IREDELL COUNTY HEALTH DEPARTMENT

IMPROVEMENT PERMIT / AUTHORIZATION TO CONSTRUCT / OPERATION PERMIT / EXISTING SYSTEM

APPLICANT: Birch North Carolina APPLICANT ADDRESS: 10735 David Taylor Dr Suite 310 Charlotte, NC

SITE ADDRESS: 132 Rain Shadow Drive Mooresville, NC PHONE: ALT. PHONE:

SEPTIC FIELD LAYOUT
LOT # 3

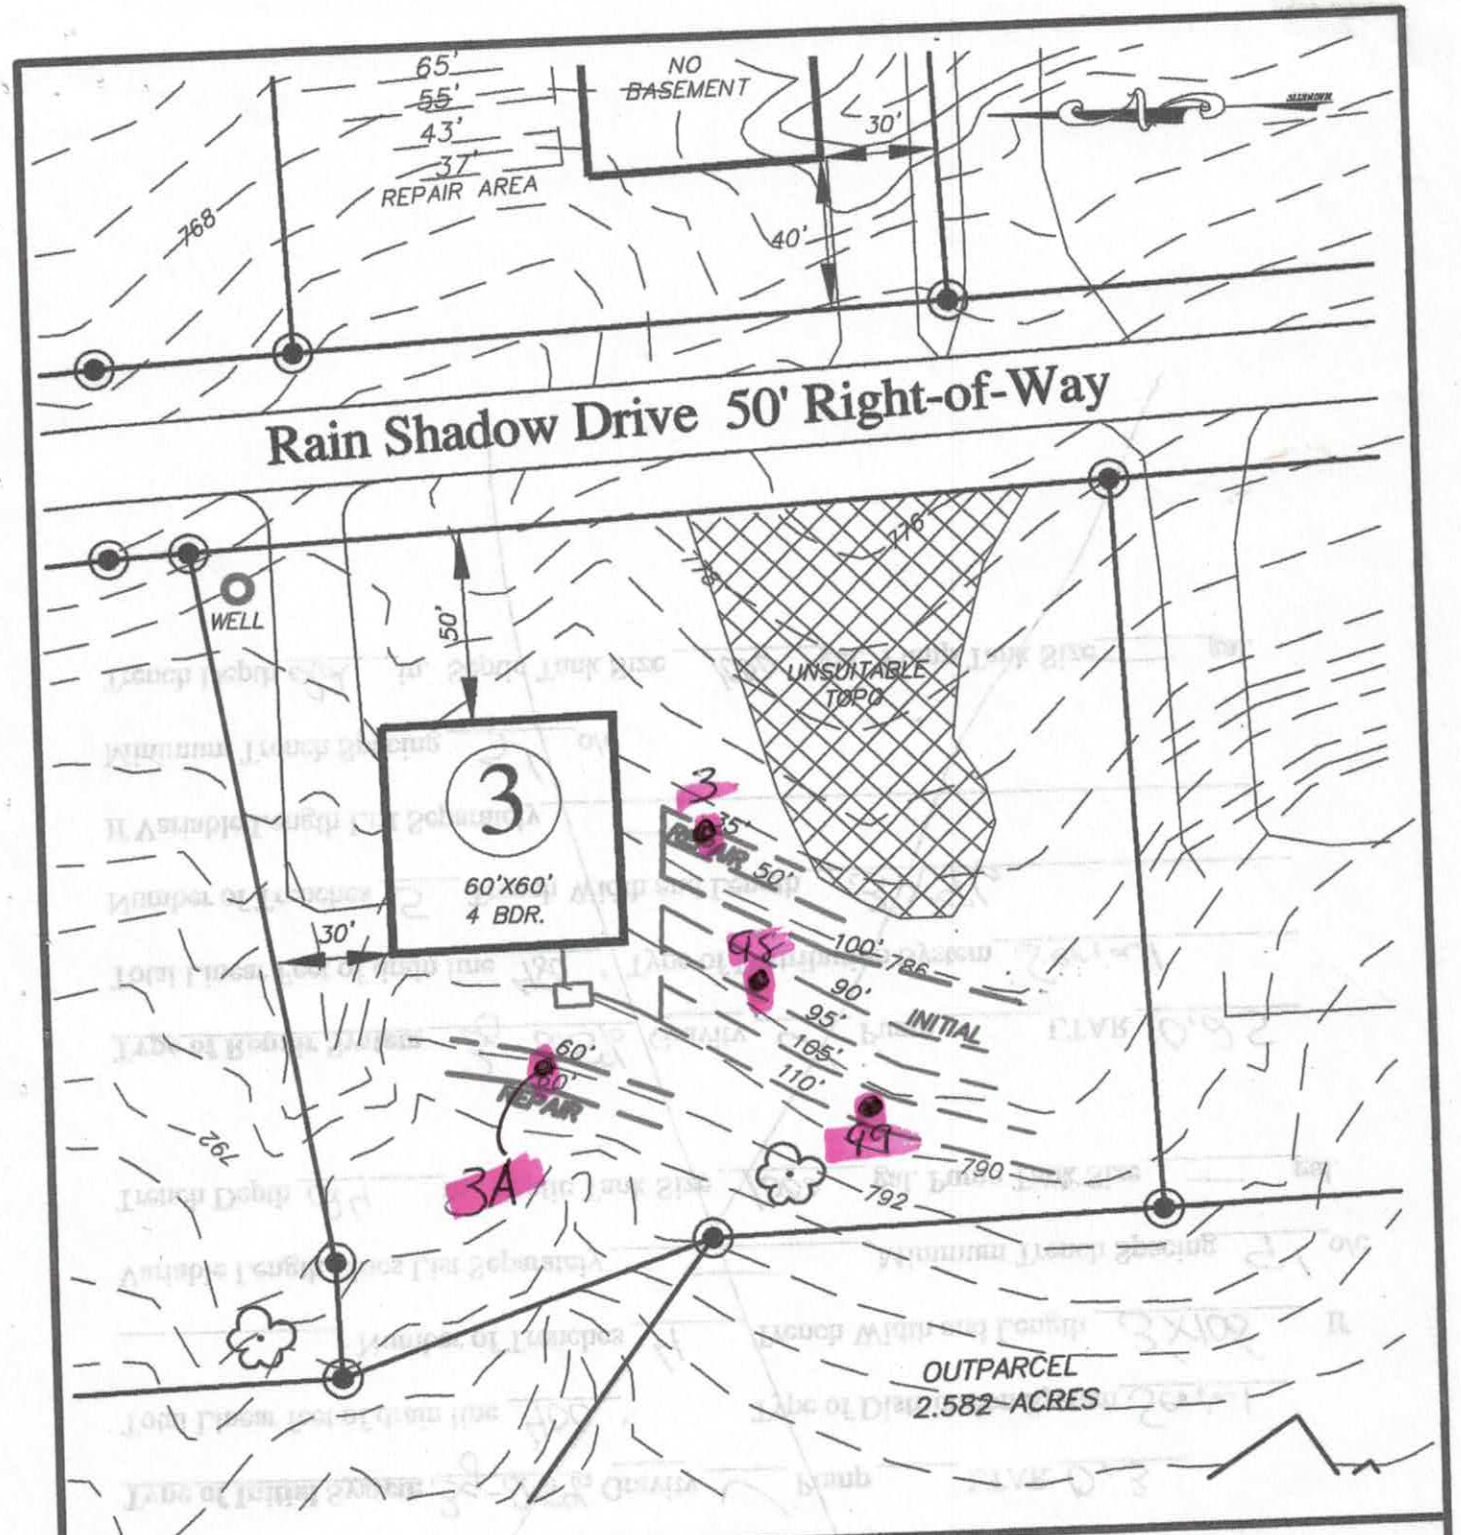
Comments / Conditions: Existing/installed system inspected on 3-1-2016 + found to not be installed in correct/approved area. This permit replaces the previous IP issued 11-4-08 (+ CA issued 4-2-15). Strongly recommend that the septic tank be pumped every 3-5 years and that non-grass vegetation be kept/cut back at least 10' from all sewage disposal system components

"Comprehensive Re-layout"

4-BR Initial System LTAR 0.3 . (4)-3'x 100' -25% Red. Serial Dist
480gpd Repair - System . LTAR 0.3 (5)-@ 100', 50', 35', 60', 60', 50% -PPBPS - LPP.

Actual House Plan

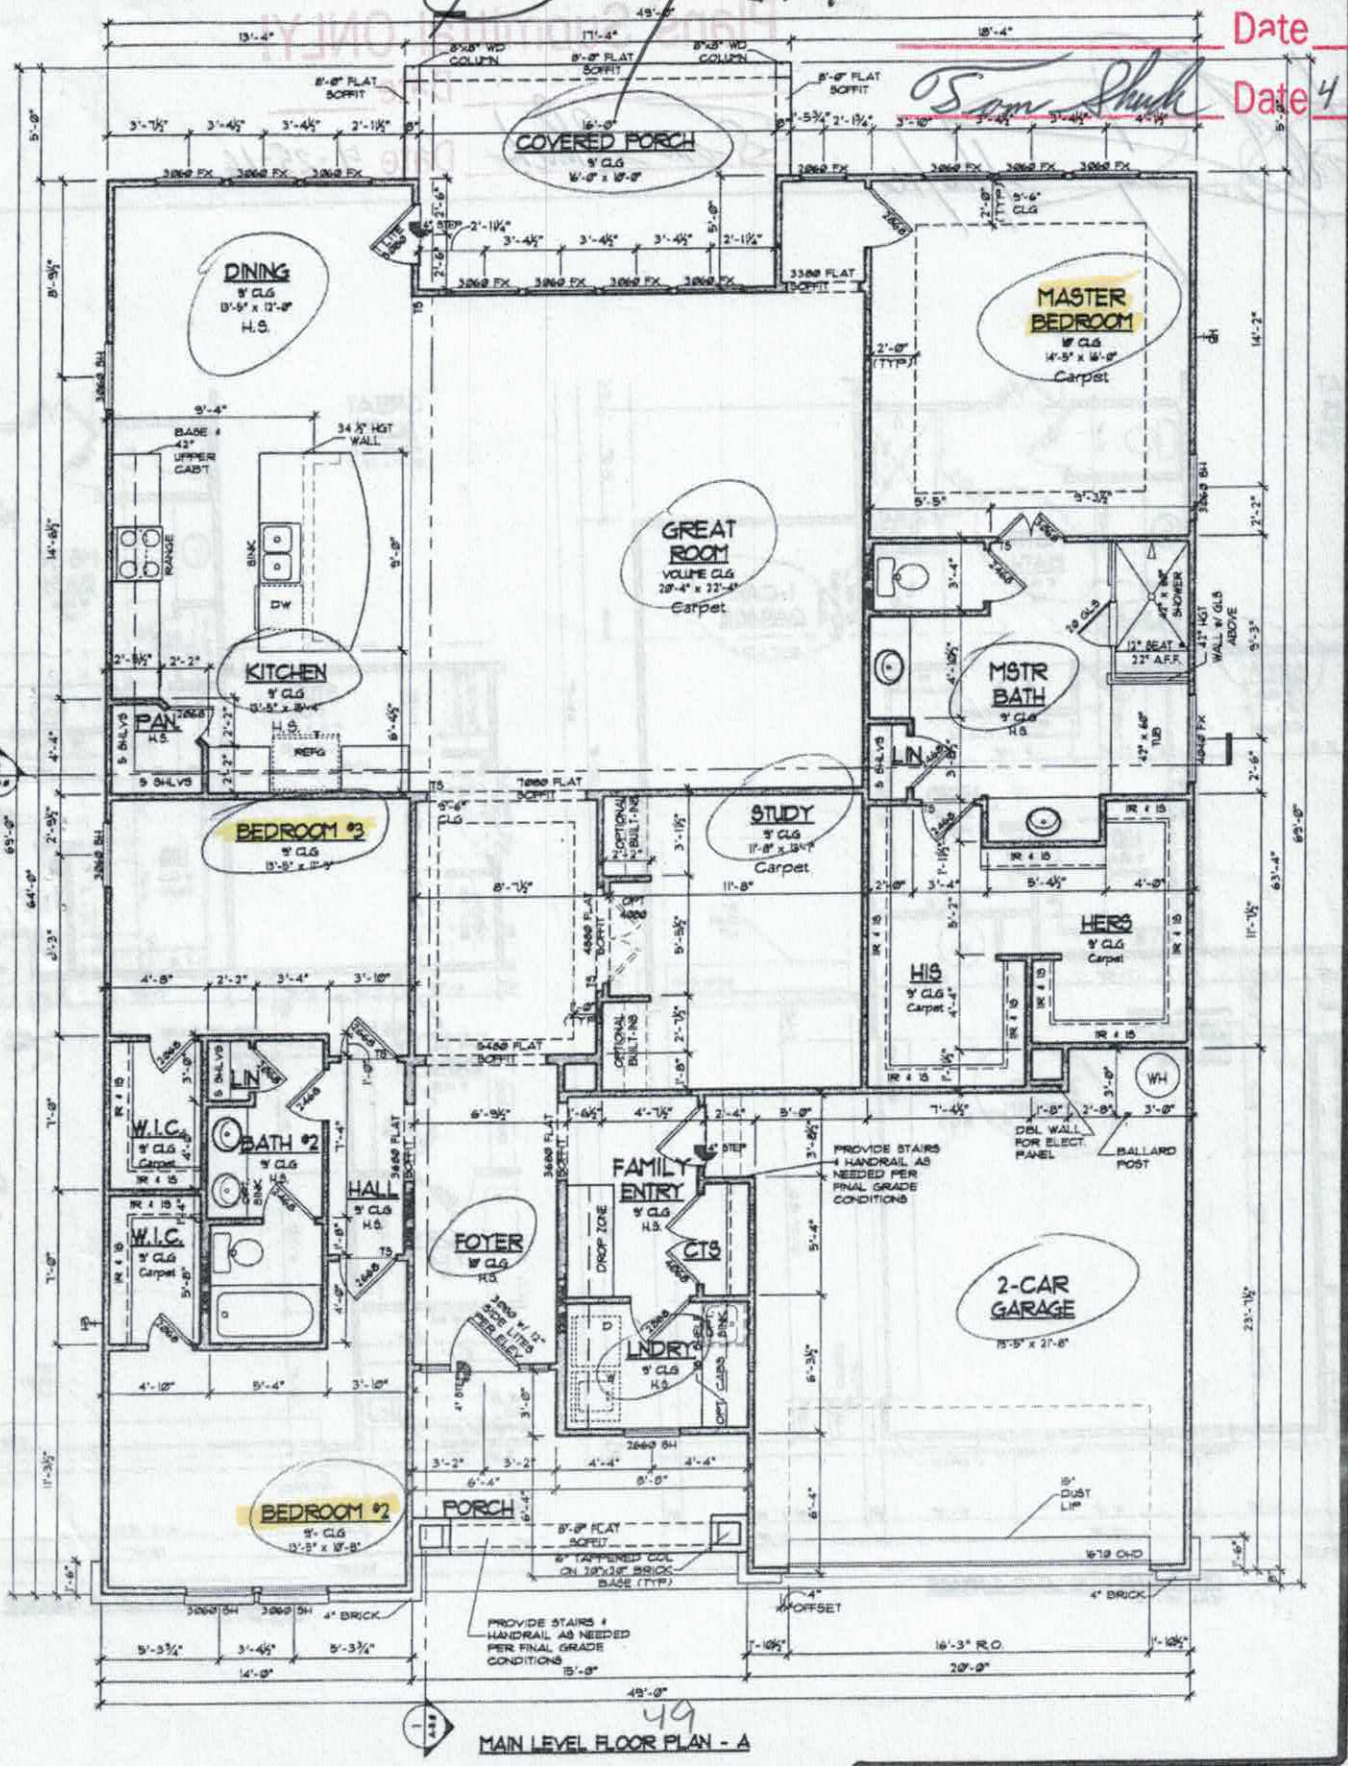
POSSIBLE OVERLAP

House Location "OK"
